March 15, 2011
U7-C-NINA-NRC-110043

South Texas Project
Units 3 and 4
Docket Nos. 52-012 and 52-013
Revised Response to Request for Additional Information

RAI 03.07.02-22**QUESTION:****Follow-up Question to RAI 03.07.02-12 and 03.07.01-13 S2 (STP-NRC-090129 & 090230)**

Figure 03.07.02-25.4: Additional node locations for acceleration comparison on the Original SSI Model (North is along Y-axis)

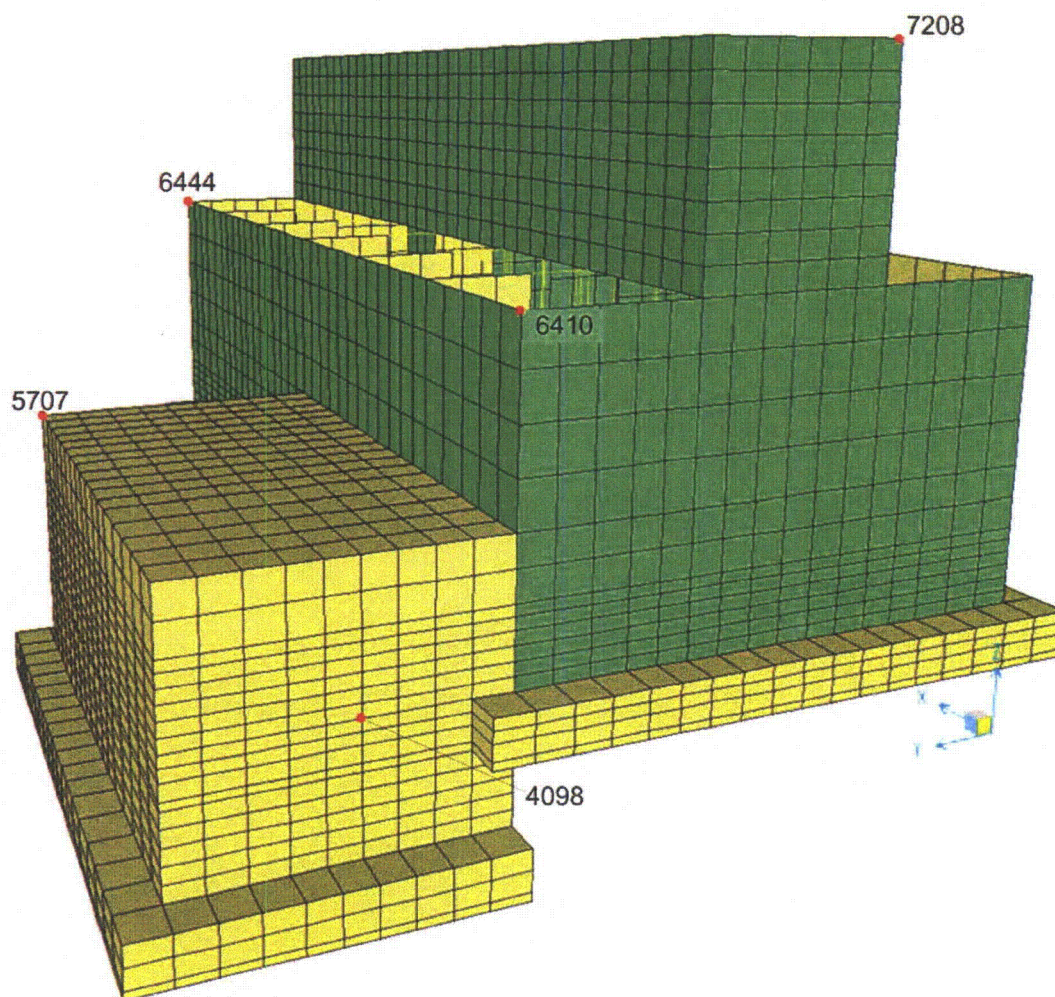
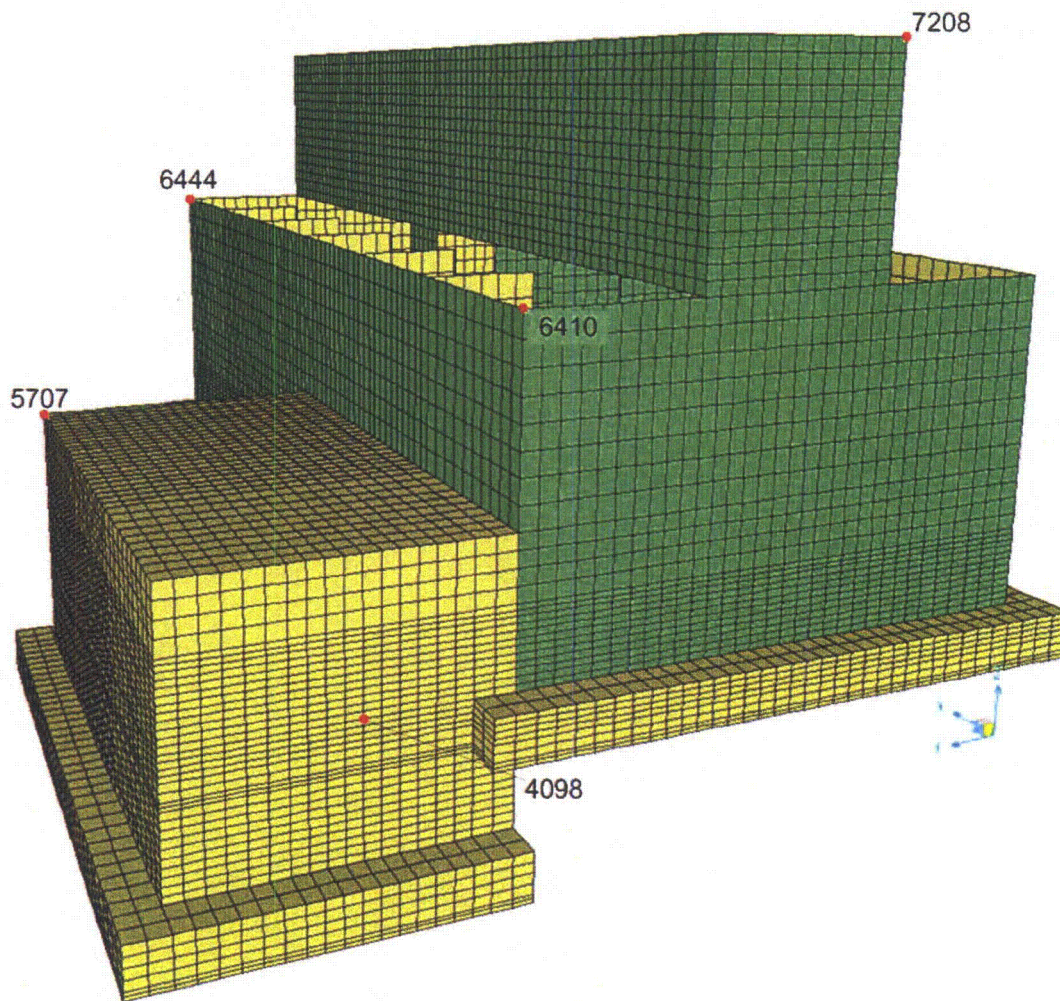
10CFR50, Appendix S requires that evaluation for SSE must take into account soil-structure interaction (SSI) effects. In the response to Item 1 of RAI 03.07.02-16 with regard to the adequacy of the structural mesh size used in the SSI analysis, the applicant has presented comparisons of the first two modes of the fixed-base structure in the E-W direction ($f_1 = 2.133$ and $f_2 = 2.056$ Hz) and N-S direction ($f_1 = 3.187$ and $f_2 = 3.028$ Hz) calculated using the SSI and design meshes. Although the comparisons of the two modes are good, they only represent a mass participation of about 17.1% and 15.4% for the E-W and N-S directions, respectively. In addition, the local modes are not reflected in these comparisons. As such, the applicant is requested to provide comparisons of the higher modes that include the out-of-plane modes of the slabs and walls to ensure the adequacy of the SSI mesh for transmitting frequencies of at least 33 Hz. This should include comparisons of in-structure response spectra of slabs, roofs and wall panels for the fixed-base structure calculated using the coarse SSI and fine design meshes subject to representative horizontal and vertical foundation motions. The staff needs this information to determine that the coarse mesh size (for modeling the structure) used in the SSI analysis is adequate for evaluation of SSI effect.

- The node locations for comparison of in-structure response spectra are shown in Figures 03.07.02-25.1 thru 03.07.02-25.3 for the original SSI model, refined SSI model, and refined structural model, respectively. These locations include the Pump House Operating Floor, Pump House Roof, UHS Basin Walls, and UHS Cooling Tower Walls. The node locations for comparison of maximum accelerations, in addition to those locations for comparison of in-structure response spectra, include those shown in Figures 03.07.02-25.4 and 03.07.02-25.5.
